UNITED STATES PATENT AND TRADEMARK OFFICE

Office Action Summary

09/954,994

DETAILED ACTION

Annotated figure showing the dotted longitudinal line

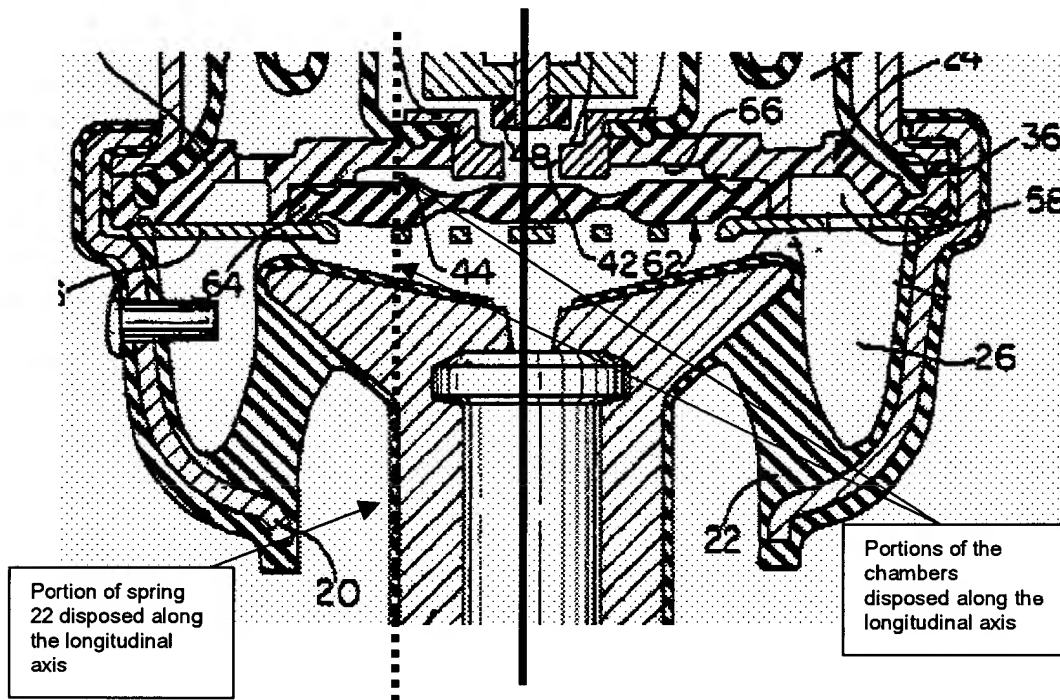
With regards to claim 1, Applicant argues that Shores, as modified, fails to disclose the limitation wherein "the pneumatic actuator has disposed along the longitudinal axis a non-linear spring, at least one upper pressure chamber and one lower pressure chamber...." Examiner notes that the dotted line in the annotated figure shown on pg. 6 of this action illustrates the limitation of the actuator having disposed

along the longitudinal axis or dotted line, a spring 22 and at least one upper and lower pressure chambers 44 and 26, respectively.
